City of Portland, Maine – Building or Use Permit Application 389 Congress Street, 04101, Tel: (207) 874-8703, FAX: 874-8716

**BUILDING PERMIT APPLICATION:
Front Porch and Entry Doors
271 Spring Street, Portland, ME 04102**

BUILDING PERMIT REPORT

DATE: 18 OCT. 99 ADDRESS: 271 Spring St. CBL: 056-G-047
 REASON FOR PERMIT: To Construct new front porch & doorway
 BUILDING OWNER: Kingsley & Dyer
 PERMIT APPLICANT: _____ Contractor Dyer & Greenleaf
 USE GROUP R-2 CONSTRUCTION TYPE 5B

Stairs

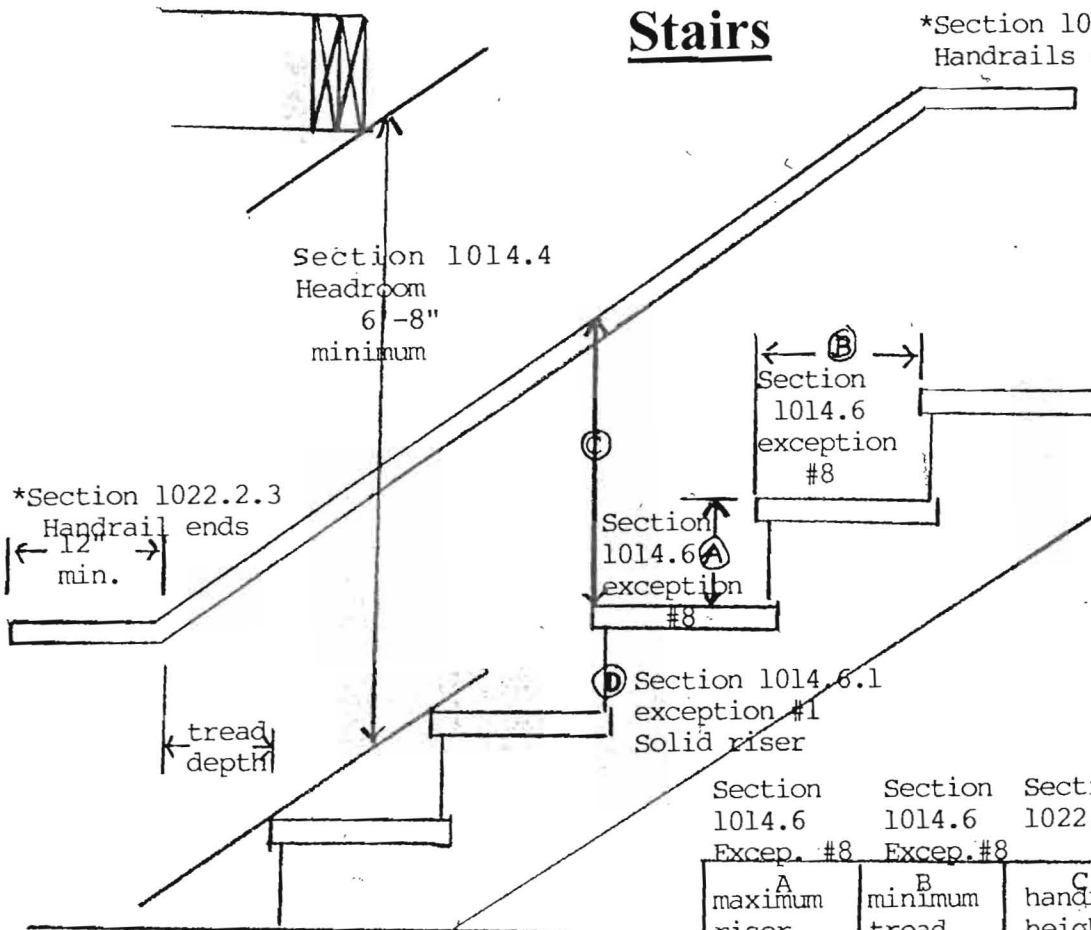
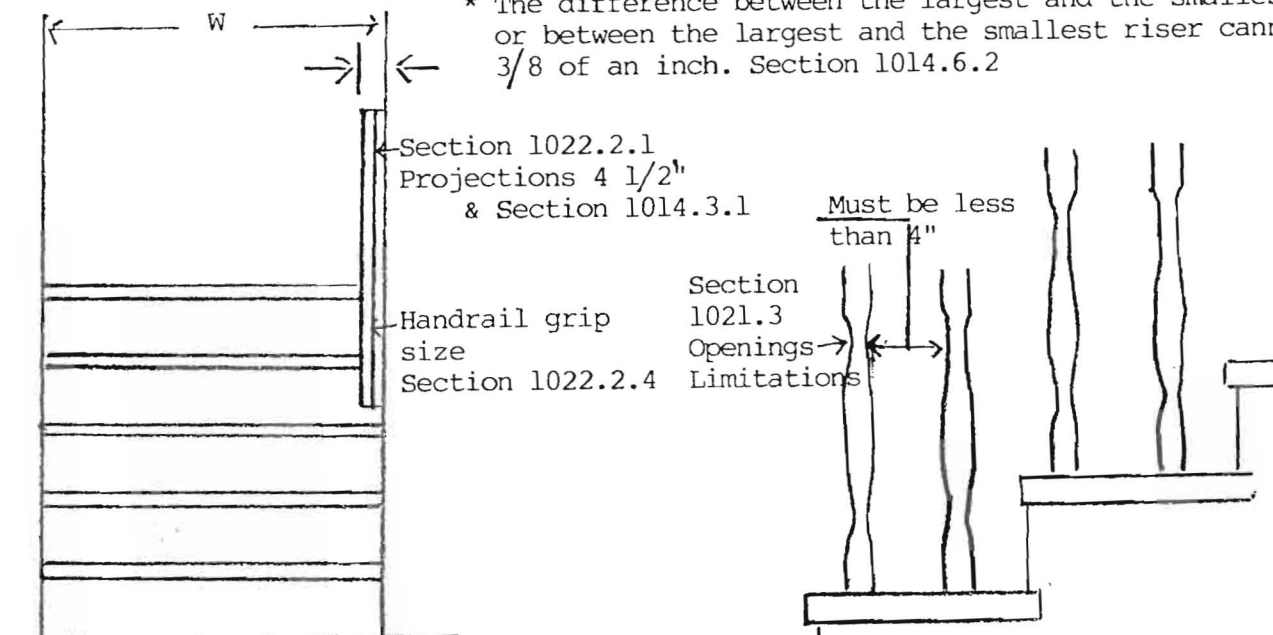
10. Sound transmission control in residential building shall be done in accordance with Chapter 12, Section 1214.0 of the City's Building Code.
- X 11. Guardrails & Handrails: A guardrail system is a system of building components located near the open sides of elevated walking surfaces for the purpose of minimizing the possibility of an accidental fall from the walking surface to the lower level. Minimum height all Use Groups 42", except Use Group R which is 36". In occupancies in Use Group A, B, H-4, I-1, I-2, M and R and public garages and open parking structures, open guards shall have balusters or be of solid material such that a sphere with a diameter of 4" cannot pass through any opening. Guards shall not have an ornamental pattern that would provide a ladder effect. (Handrails shall be a minimum of 36" but not more than 38". Use Group R-3 shall not be less than 30", but not more than 38".) Handrail grip size shall have a circular cross section with an outside diameter of at least 1 1/4" and not greater than 2". (Sections 1021 & 1022.0) - Handrails shall be on both sides of stairway. (Section 1014.7) UNLESS HISTORICAL PRESERVATION requires and approved by you

12. Headroom in habitable space is a minimum of 76". (Section 1204.0) Plan - IF follow code requirements
- X 13. Stair construction in Use Group R-3 & R-4 is a minimum of 10" tread and 7 1/2" maximum rise. All other Use Group minimum 11" tread, 7" maximum rise. (Section 1014.0) NO NOSING
